ZONING PERMIT APPLICATION

FULL NAME GEORGE DEBECIK TELE # 612-770-9210
 MAIL ADDRESS 10635 NORTHMARK Drive
 CITY Eden Prairie STATE MN ZIP 55344
 911 ADDRESS OF PROPERTY 29986 436th Place
 CITY Aitkin STATE MN ZIP 56431
 TOWNSHIP FARM ISLAND
 LEGAL DESCRIPTION LOT 9 - SHADY ACRES PLAT
 SECTION 28 TOWNSHIP 4.6 RANGE 27

Permit App 41811

This permit application was withdrawn. I'm attaching the email conversations and also some of the drawings. This is a small lot and is difficult to meet setbacks.

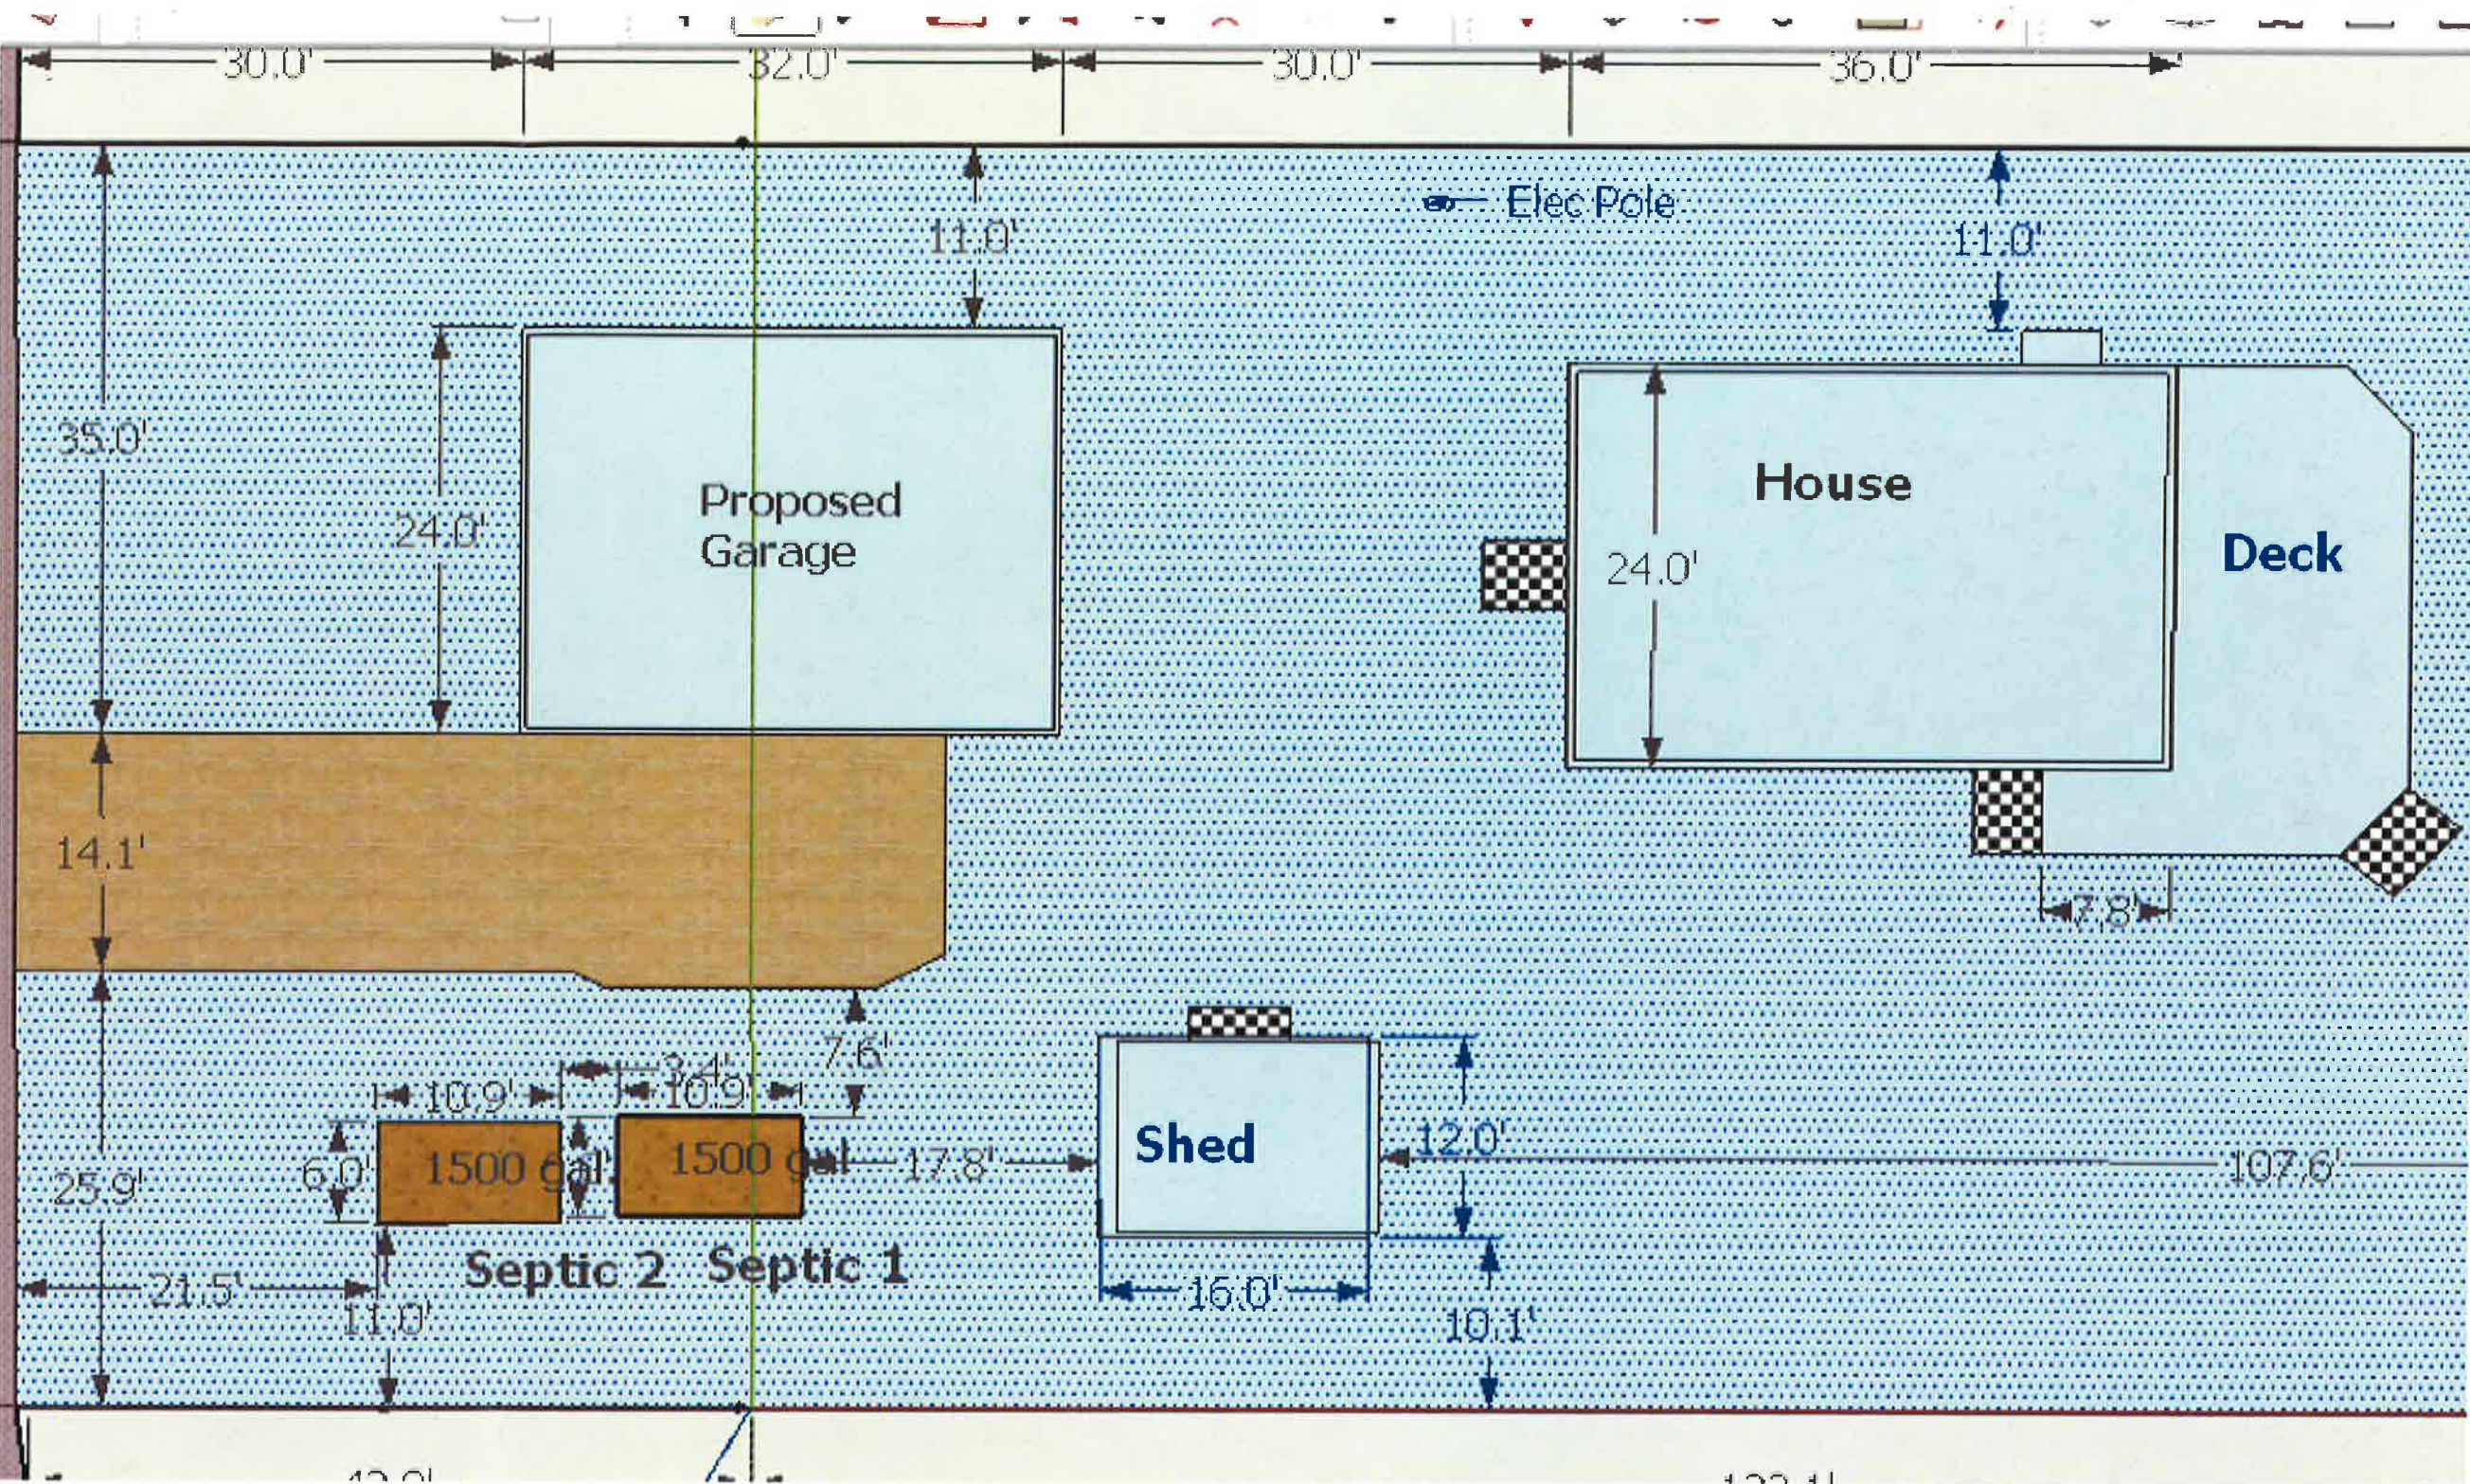
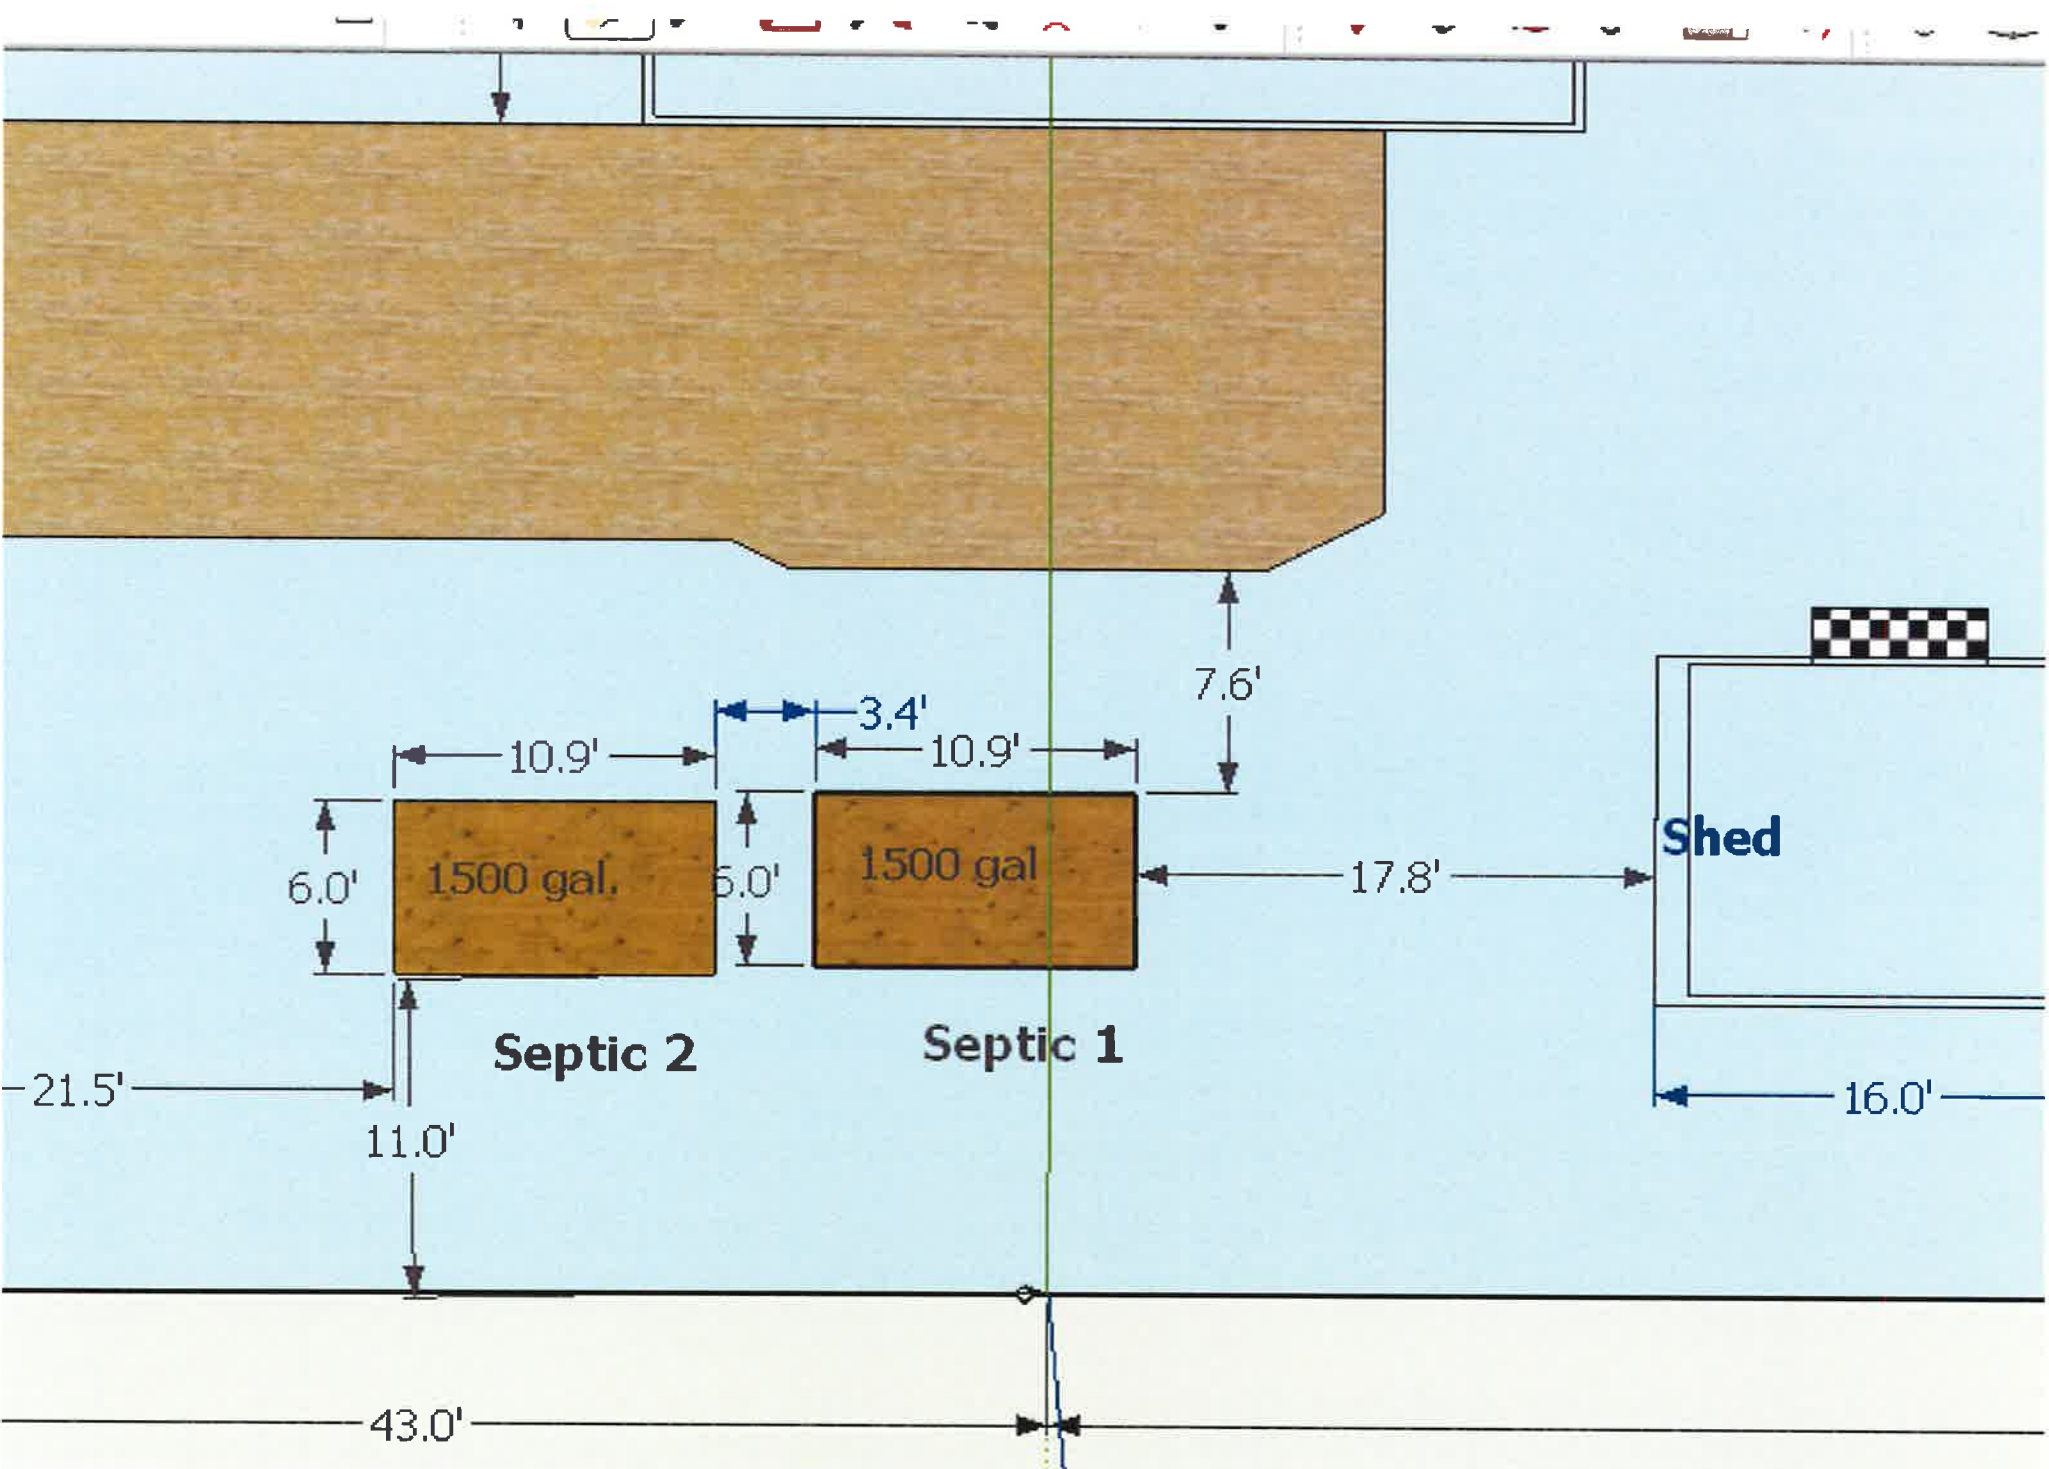
OK..I got the details. The cabin was built with shoreline averaging, but that only applies to a primary residence structure, and not to any accessory structures. The 12 x 16 shed would have to meet all standard setbacks, including the 100 feet lake setback. I measured the garage setback from the lake and got 108 feet from the ordinary high water line on that side of the lot. I'm not sure if where you proposed the shed to be moved meets the 100' setback. It would also need to meet a 10 tanks setback to the structure, which may be possible. I know your drawing isn't quite to scale (although it's a very nice drawing), maybe it can be worked in. If not, maybe removing that structure allows you to leave the decks alone, and with the garage, you may not need the extra shed.

I'm checking on moving the shed. My supervisor is helping at the counter right now. Normally any structure has to meet all setbacks unless it has a variance or if it's a water-oriented accessory structure (WOAS). A WOAS has to meet all setbacks except the lake, but the maximum it can be is 120 square feet and it should be in the center third of the property. I'll see if the proposed new location can work somehow.
